Addendum #2

Date	Owner Property Number	Owner Building Number	BHDA Project Number
Fri, 22 Jun 2018	505-1975	Orem UT South FM Group Building #20	1822

Project Designation	Project Address
Cherry Hill 1, 2, 4 Mother's Room Orem UT Cherry Hill Stake	1700 South 400 East Orem, Utah 84058

SHEET TITLE:
POWER PLANS

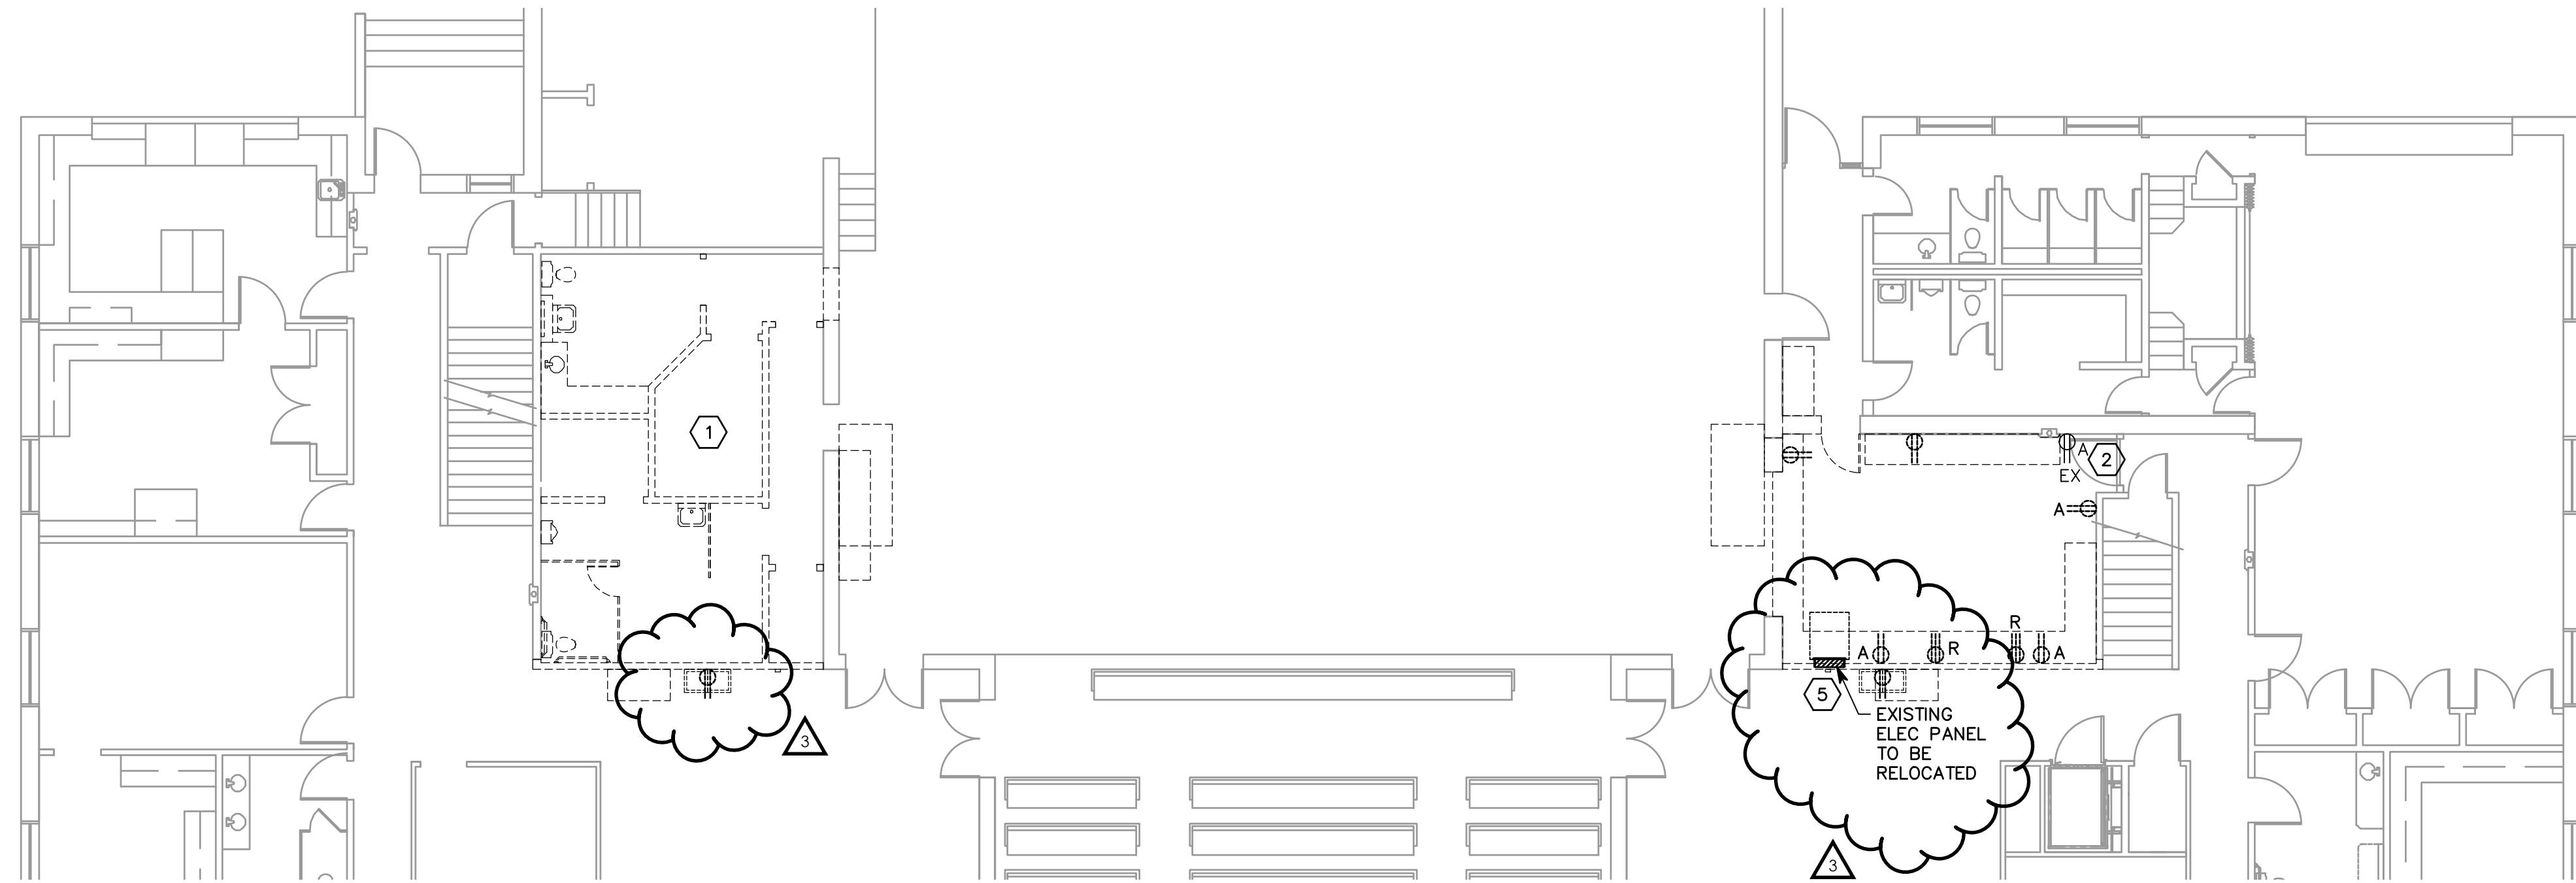
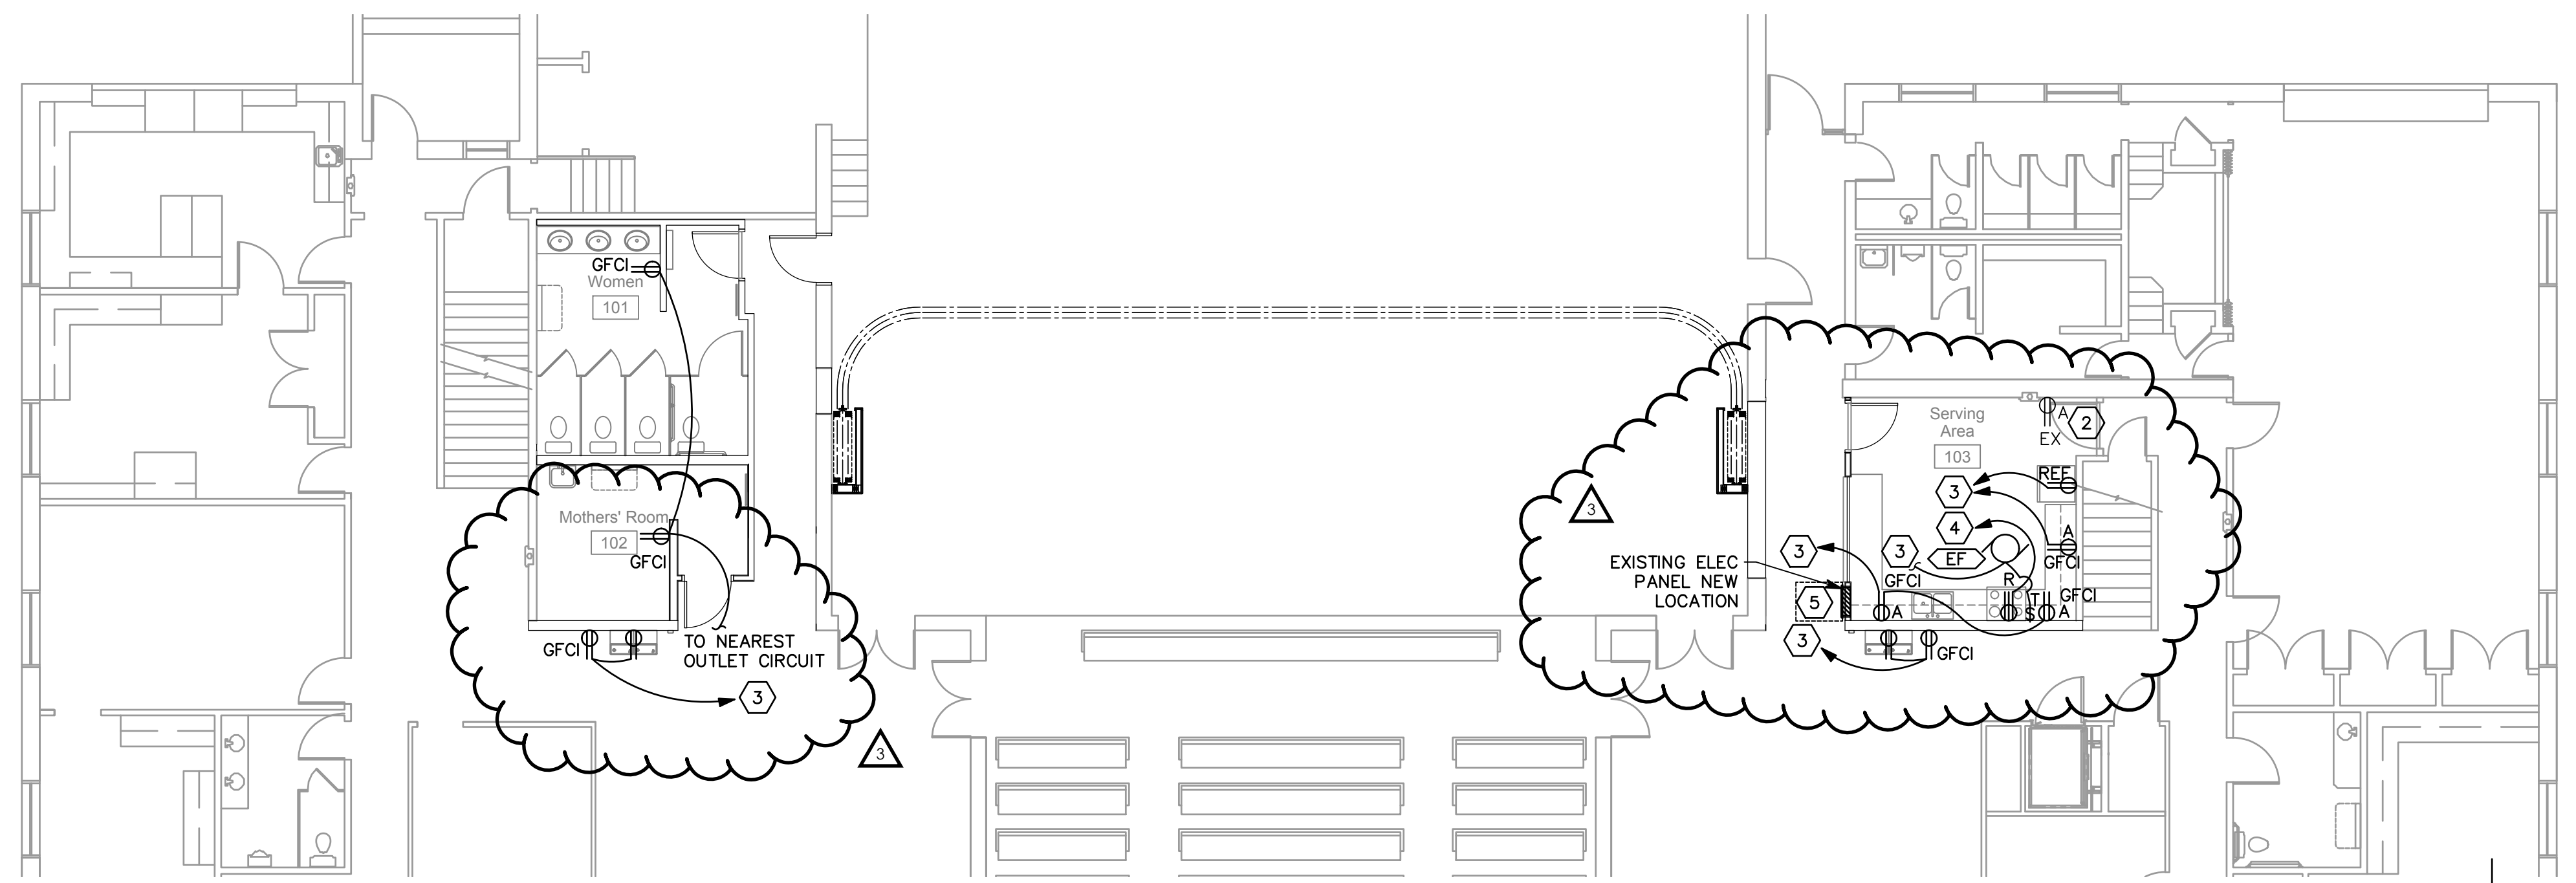
4.03. Sheet E101 Power Plans

- A. Replace this Sheet with the attached revised Sheet.
- B. Miscellaneous revisions, such as the relocation of the existing panel in the Serving Area.

SHEET TITLE:
LIGHTING PLANS

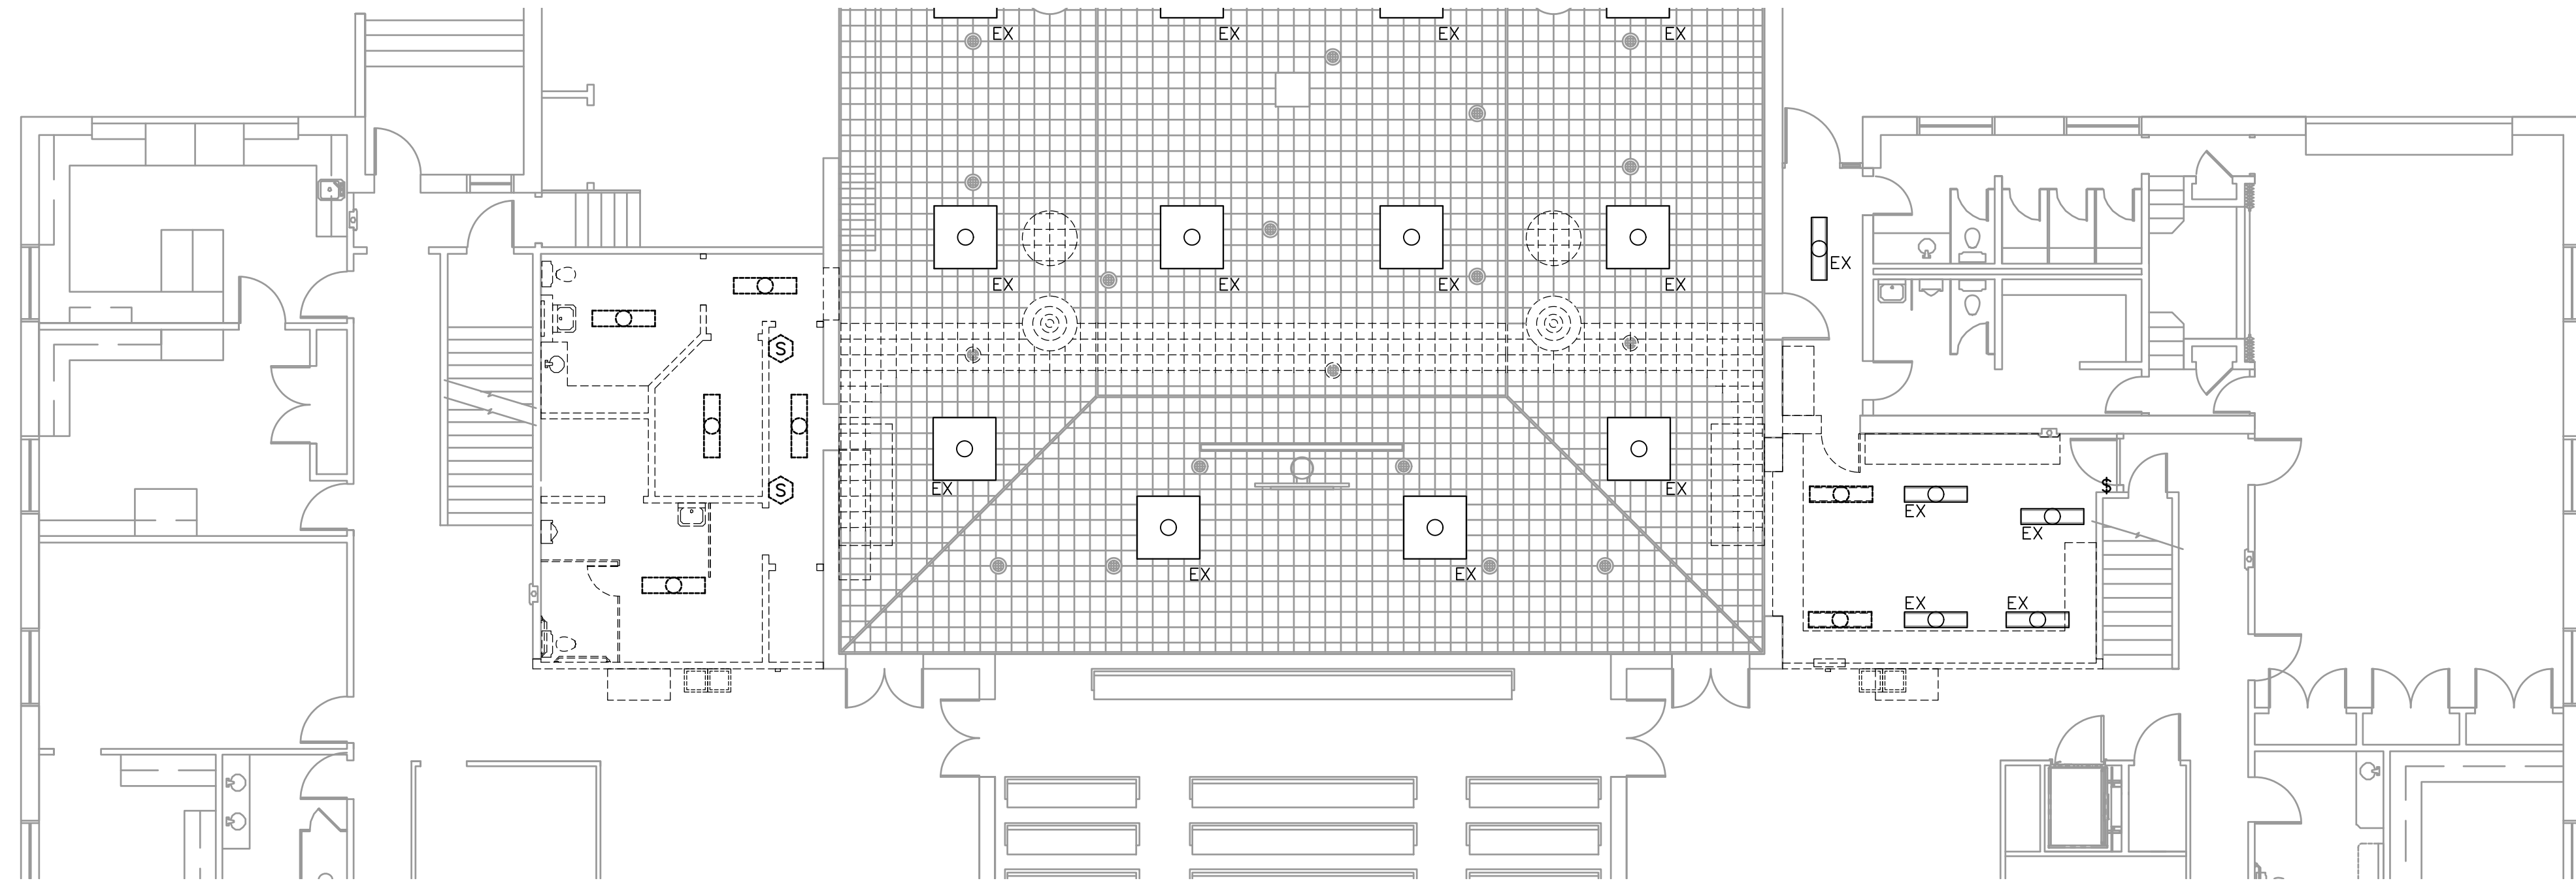
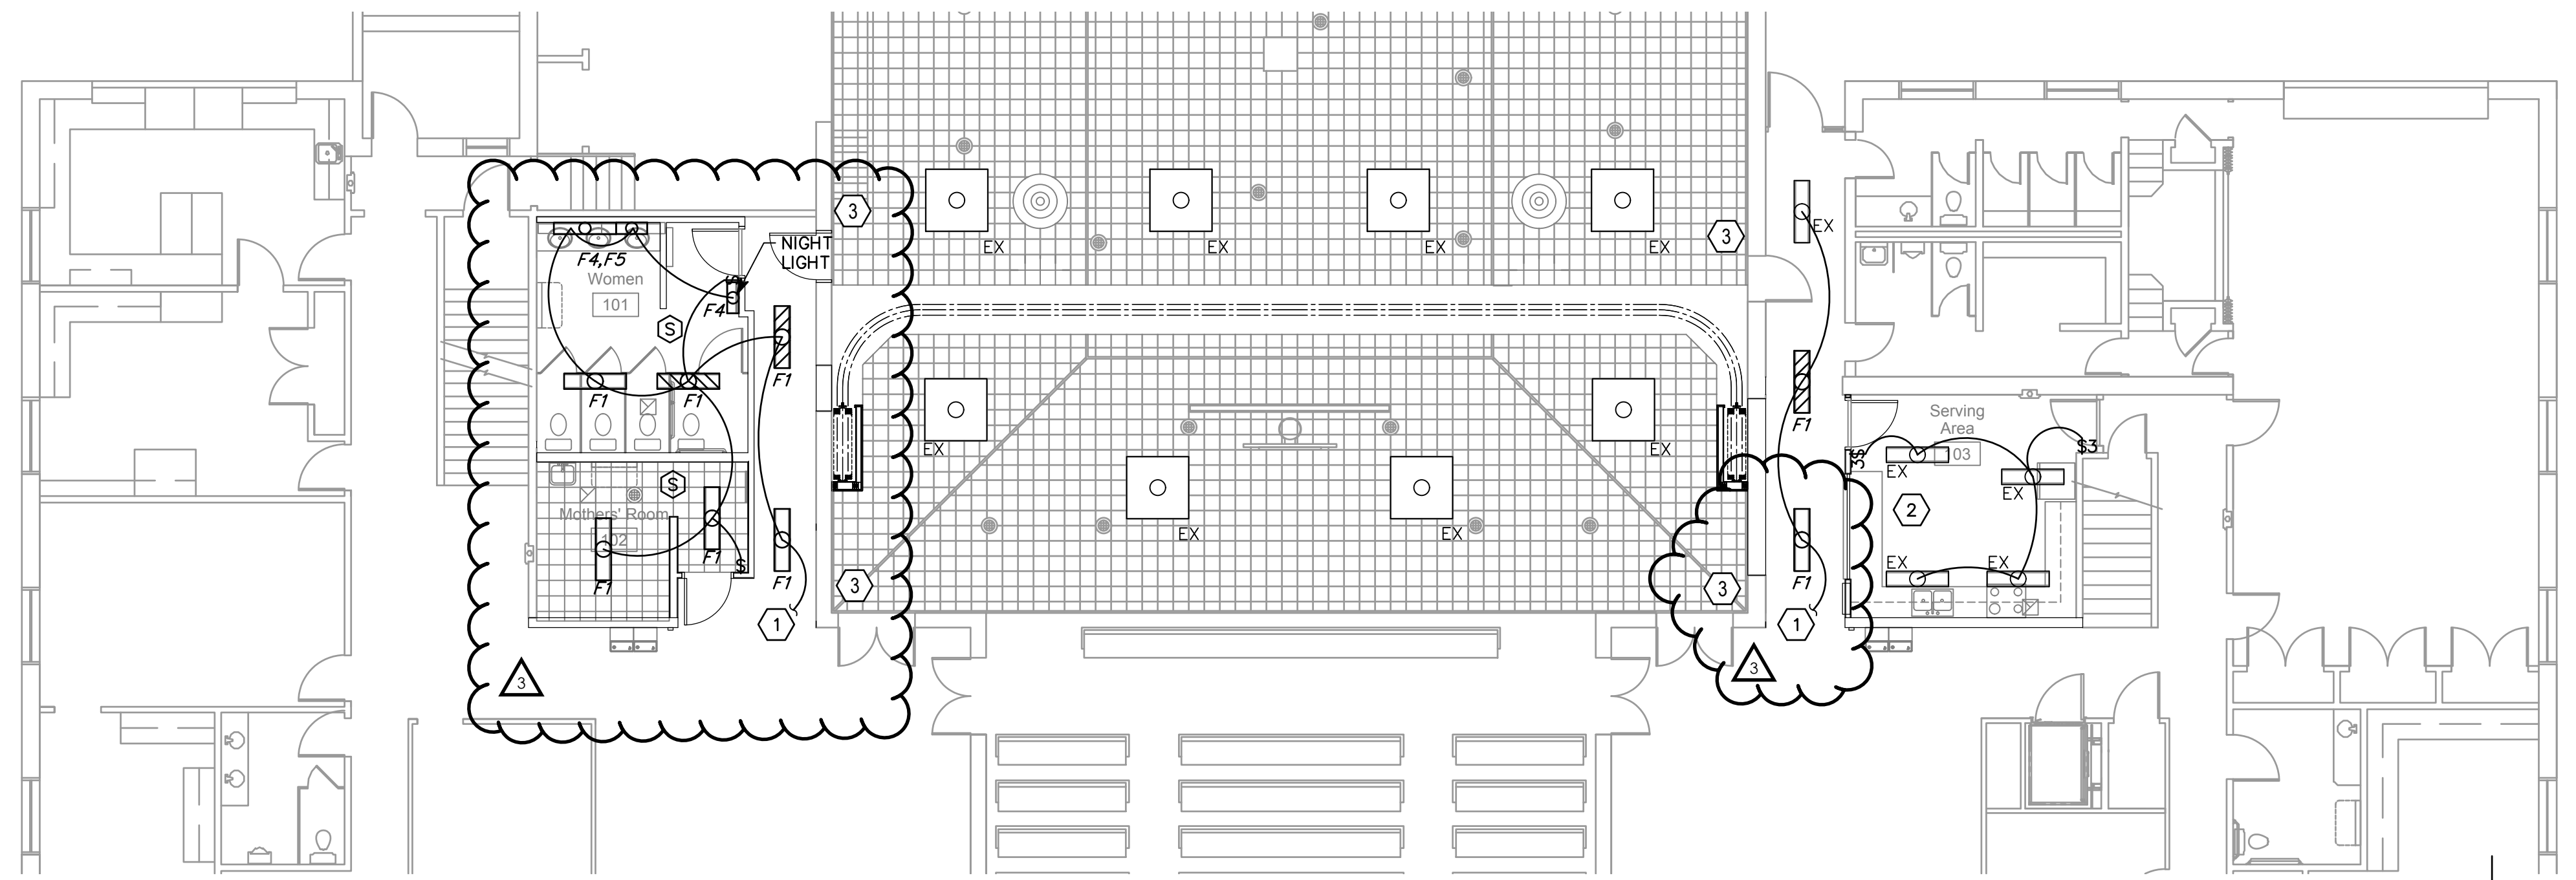
4.04. Sheet E111 Lighting Plans

- A. Replace this Sheet with the attached revised Sheet.
- B. Miscellaneous corrections, such as circuiting instructions for the hallway lights.
